Service Bulletin

Bulletin No.: 20-NA-025

Subject: Loss of Audio, Chime, or Turn Signal Click Clack, Abnormal Speaker Operation

5507591

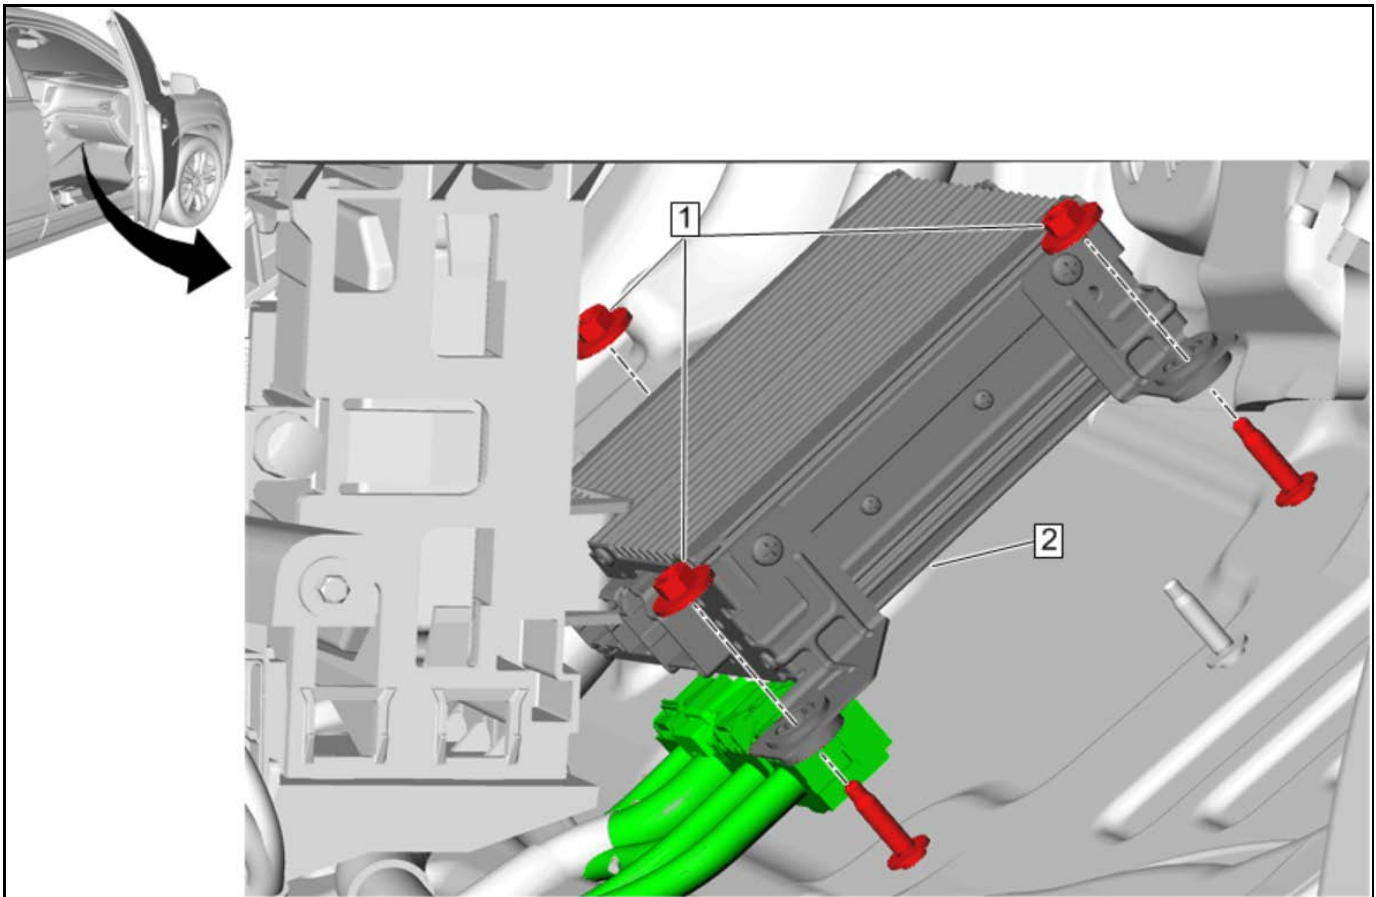
Correction

Replace the ANC module and install an ANC module secondary shield, following the steps in the Service Procedure below.

1. Front of the vehicle
2. ANC module
3. ANC module secondary shield

5507591

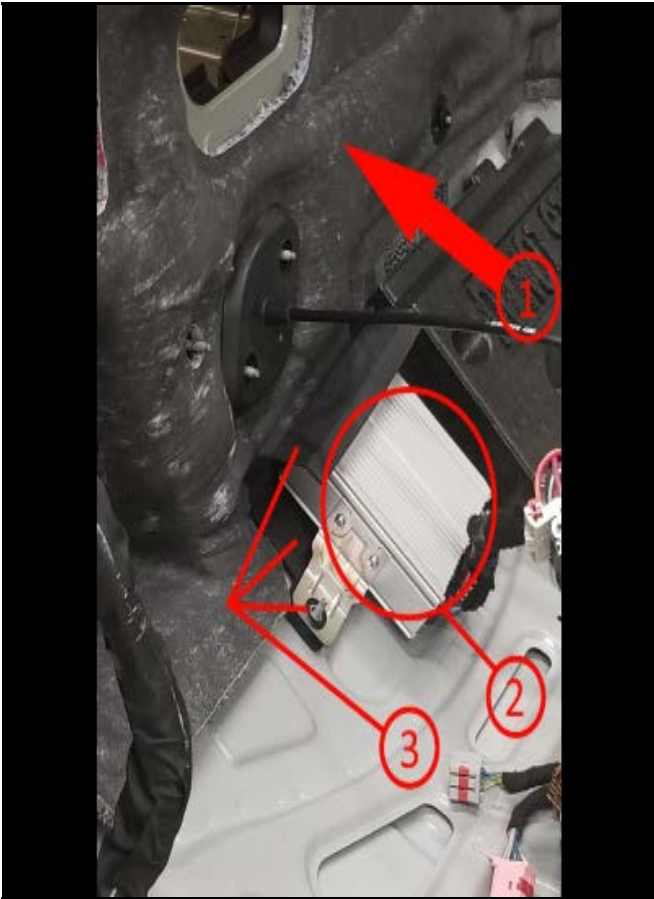
Note: The shield is installed on the studs first, then the module is installed next.

2. Replace the ANC module (2) against the front of the vehicle (1) and install an ANC module secondary shield (3).
